ADDENDUM 1

REF: Bid 2022-09 Portable Classroom Improvements at Five Schools

The following changes are made a part of the Drawings and Specifications for the project named above. Receipt of this Addendum is to be acknowledged in the space provided on the Bid Form. Failure to do so may subject the Bid to be considered as non-responsive.

1 NORTH HAGERSTOWN HIGH SCHOOL E302 1/32" = 1'-0"

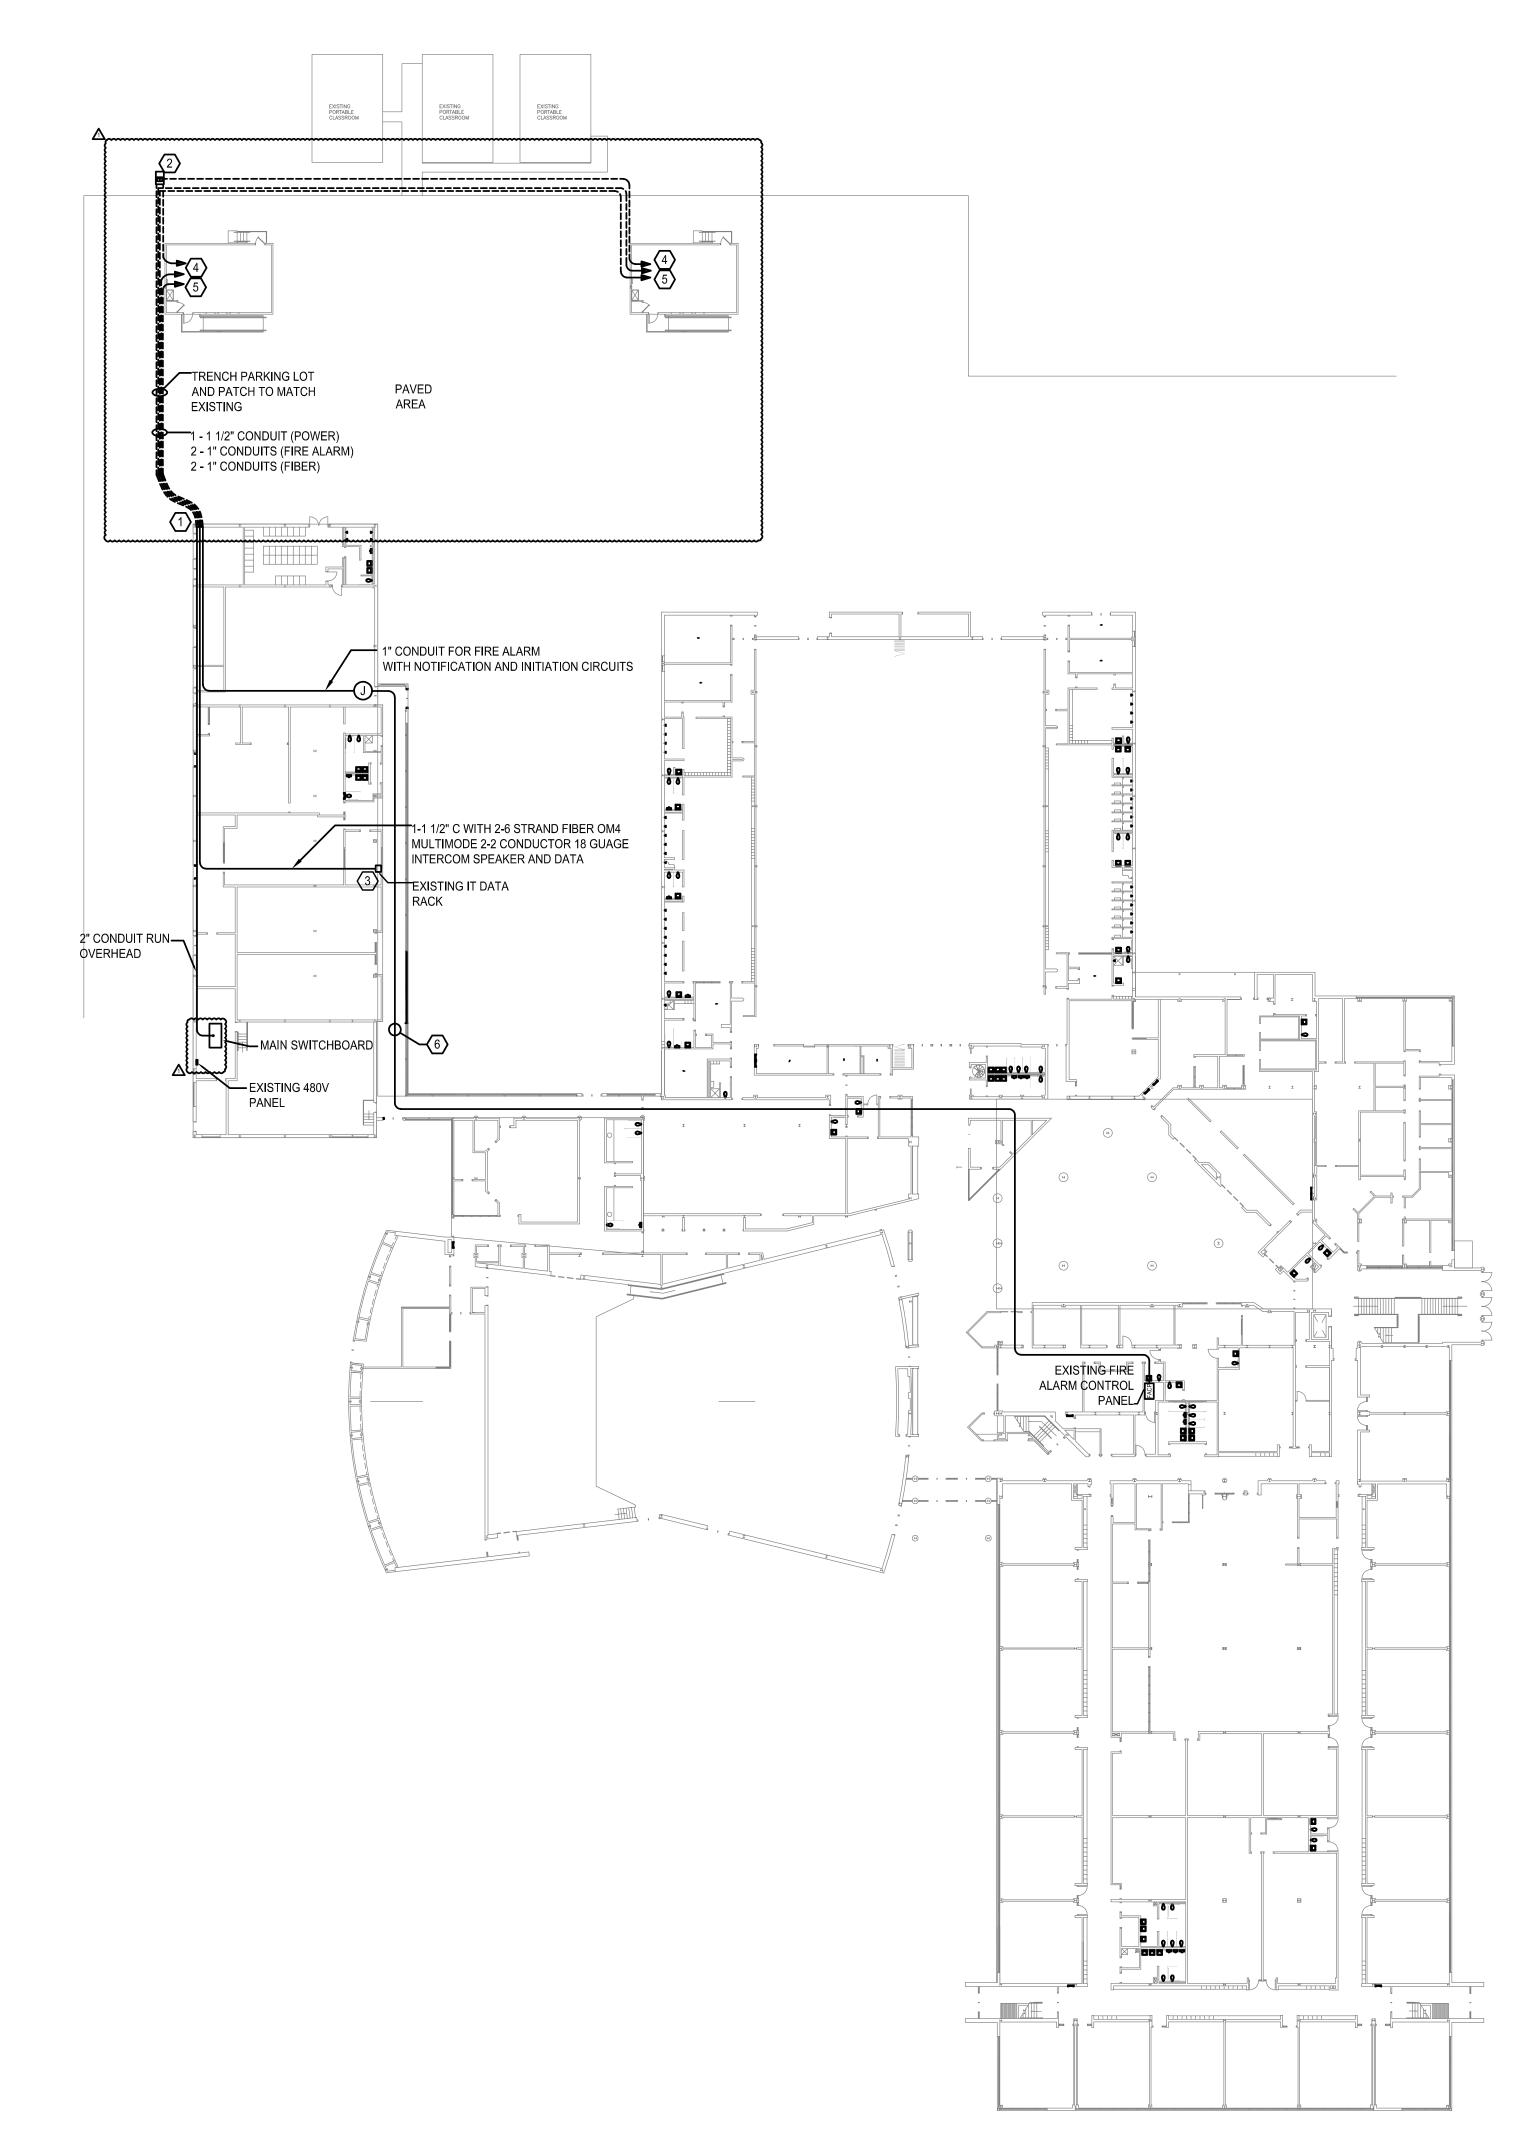
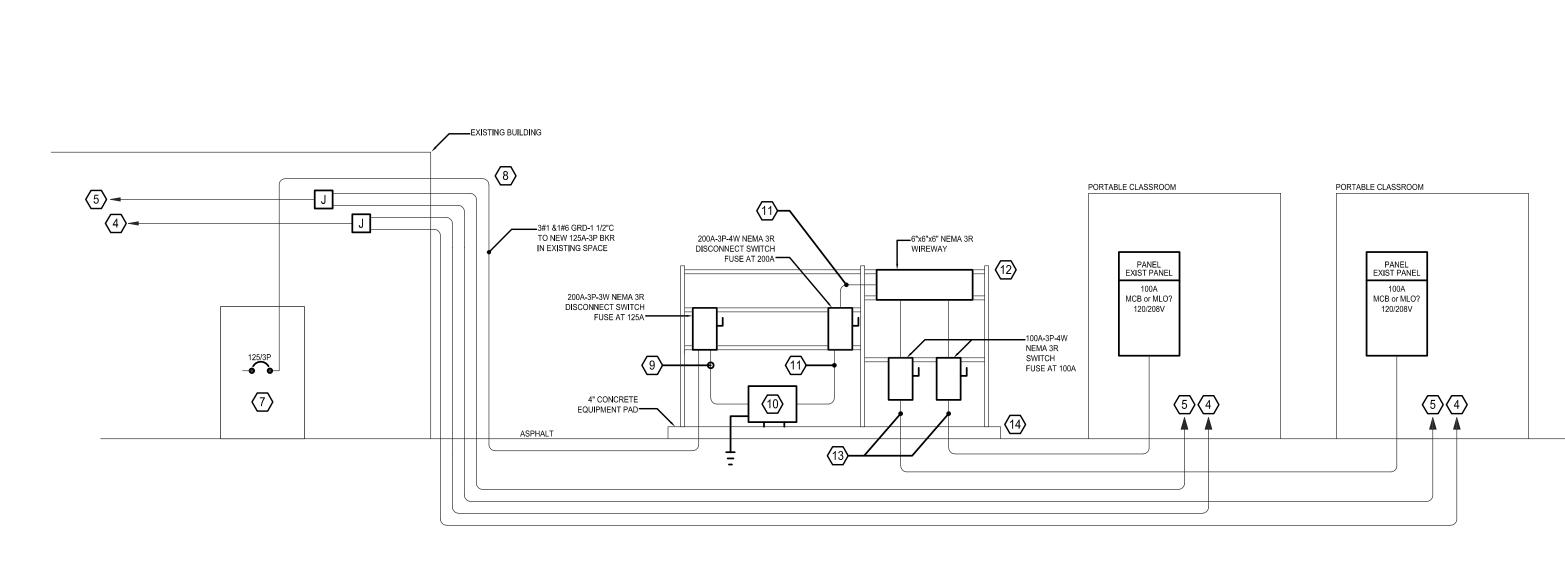
North Hagerstown HS - Consideration for source of power for the 4th & 5th/added Portables should be given to the existing Transformer/Secondary Panel NP currently feeding the existing (3) Portables via a separate metered Service from Hagerstown City Light. City Light should be able to identify average and peak demands on this service for consideration in this regard. Note that the Panel designated to add a 125A/3P Circuit Breaker per Drawing E302 Note 7 is Emergency Panel EDLF. This appears to be in error, given that no Portables at WCPS sites have previously been powered by Emergency source(s).

- 1.27 **DELETE** E302 and **REPLACE** with revised E302 attached to this addendum. Note that the incorrect portable classroom location is shown on this drawing. Bidders shall assume that new portables are 200 feet away from the plan northwest corner of NHHS, and shall route all utilities to the new location as shown on the sheets referenced in Addendum item 1.24.
- 1.28 **DELETE** E303 and **REPLACE** with revised E303 attached to this addendum.
- 1.29 **DELETE** E304 and **REPLACE** with revised E304 attached to this addendum.
- 1.30 **DELETE** E305 and **REPLACE** with revised E305 attached to this addendum.

A: See Addendum Item 1.23. Revised MEP Drawings are attached to this addendum.

JOB NUMBER:	21-0089
ISSUE DATE:	4 AUGUST, 2021
SCALE:	AS INDICATED
SHEET TITLE:	
	HTS ELEMENTARY SITE PLAN
Sheet NUMBER:

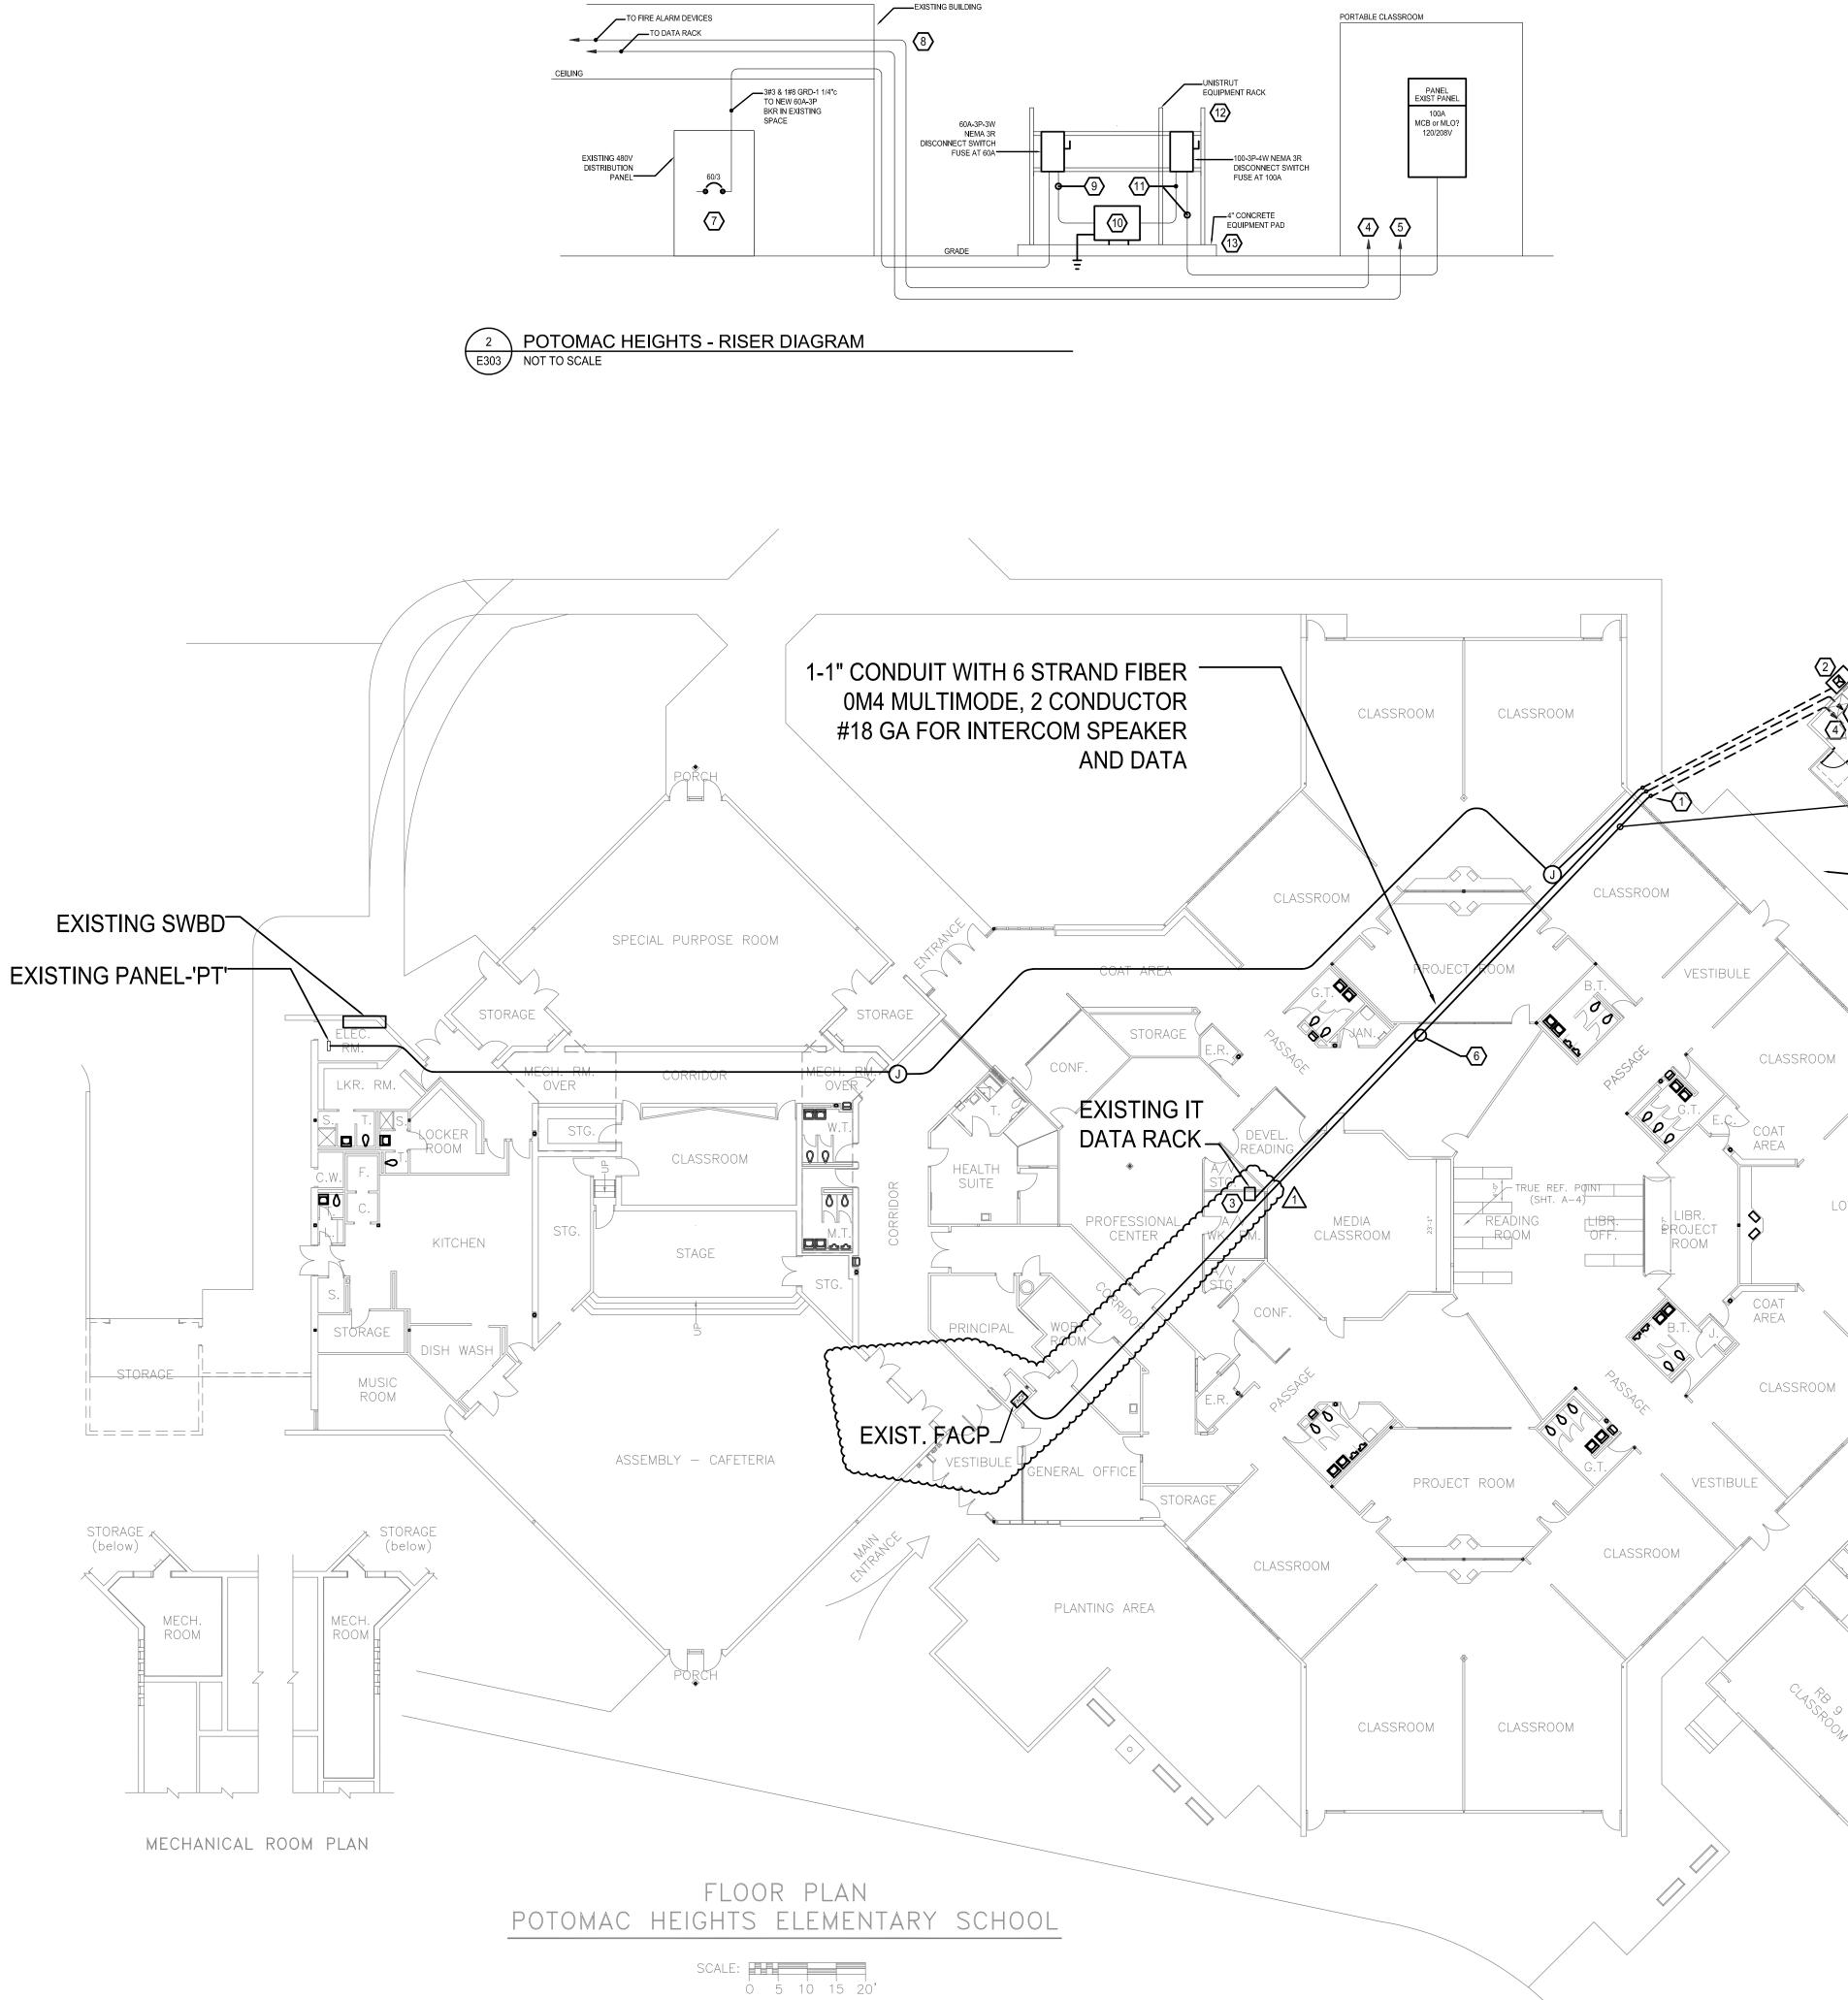
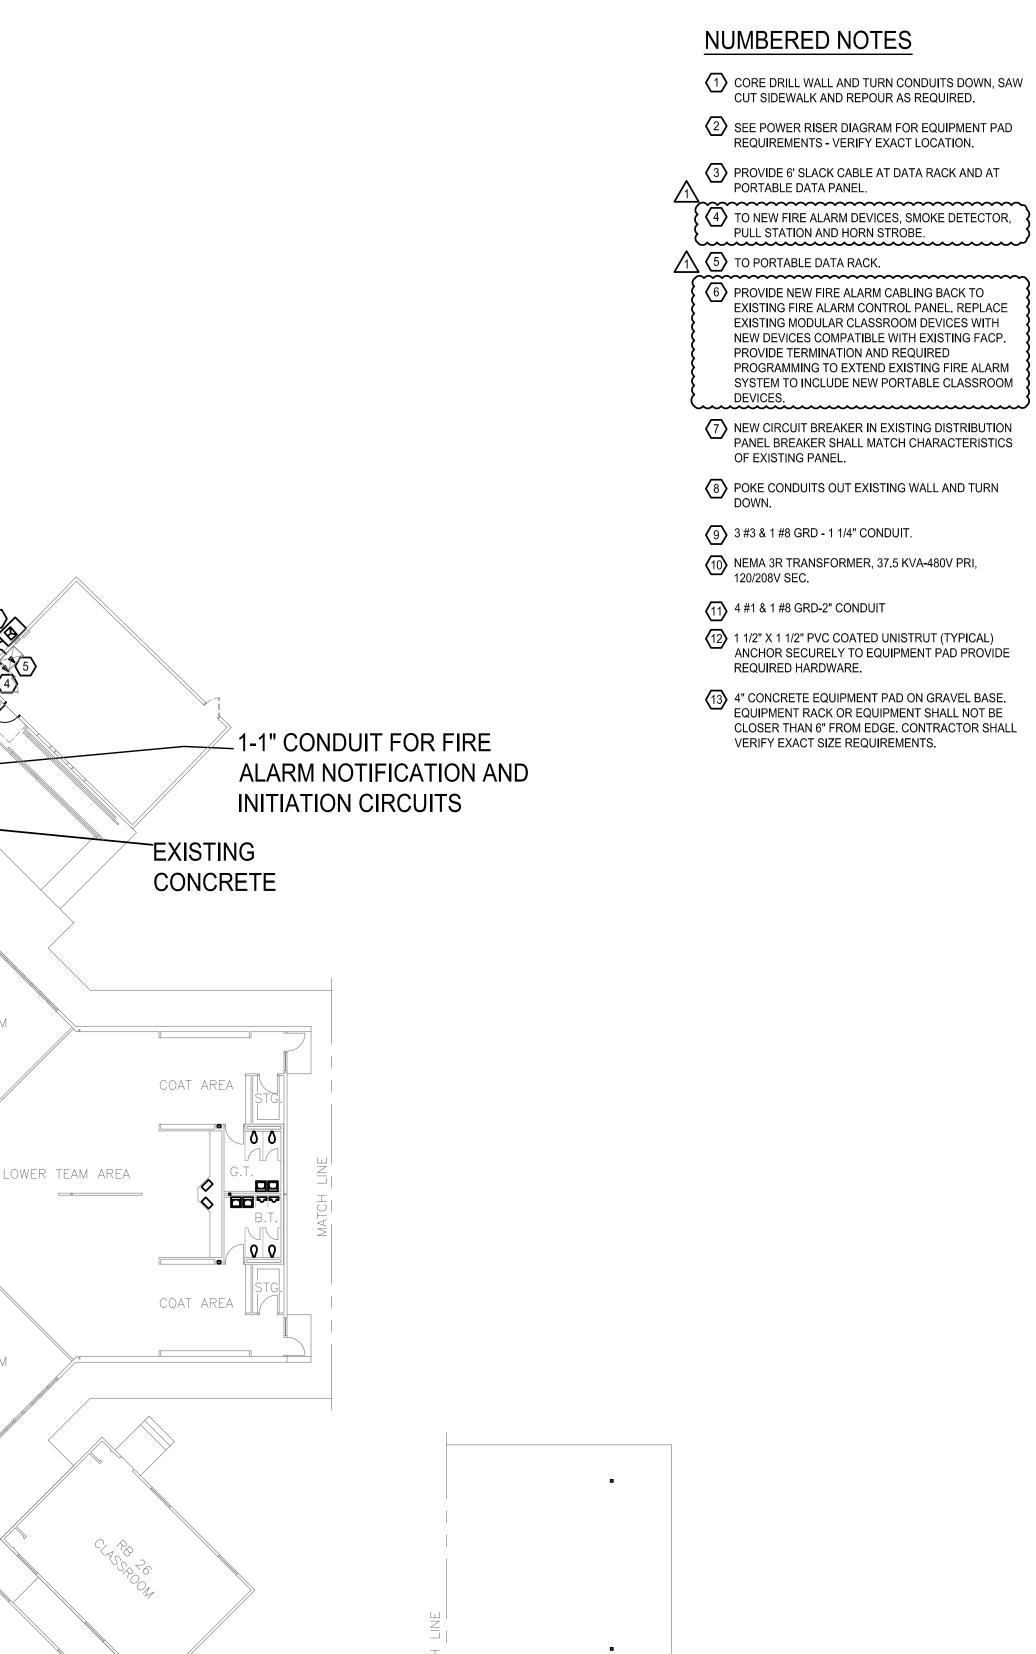
Potomac Heights ES - There is actually no Fire Alarm Control Panel (FACP) where noted on Drawing E303 in the same room with the IT Data Rack. This is actually a Honeywell Security Control Panel. The FACP along with Voice Control Panel and NAC Power Extender Panel is in a closet accessible through the Principals' Office.
